Our Ref: R/2023/2  
File No: 2023/113693  
Your Ref: SSD-39971796

**Chief Mechanical Engineers Building – SSD 39971796 – Advice on EIS**

#### 1.1.2 Verandah

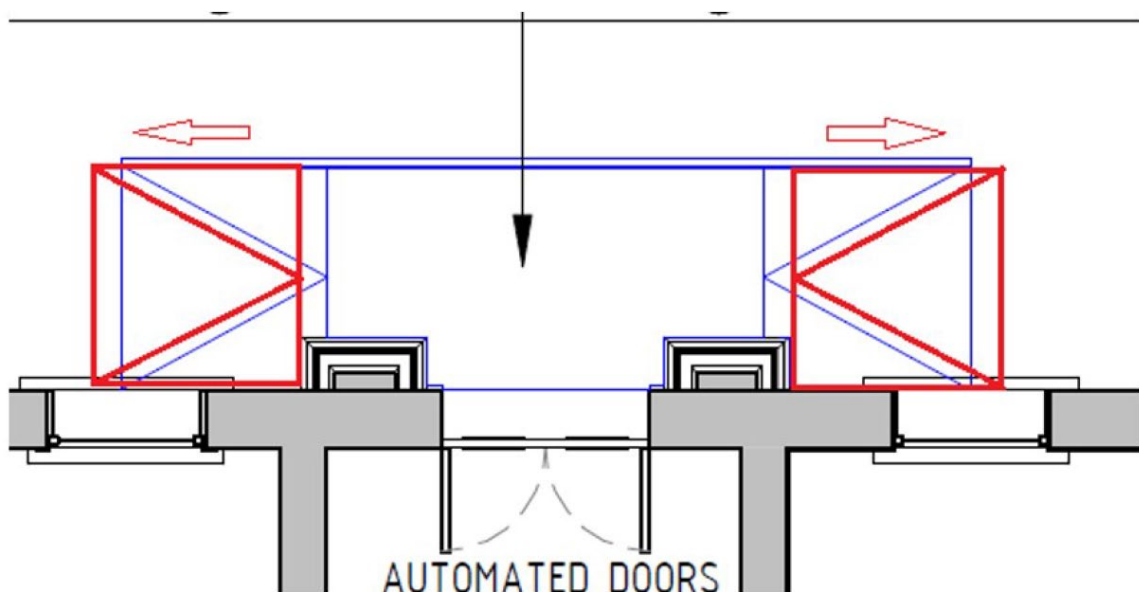
The proposed ramp in front of G9 entry can be supported subject to a minor amendment. The landing area is recommended to be increased in length slightly to align with the far edges of the moulding of the columns to avoid impact on the decorative mouldings at the base of the columns. The ramped portions are recommended to be located slightly away from the columns as per the image below. The design approach otherwise for this ramp is supported.
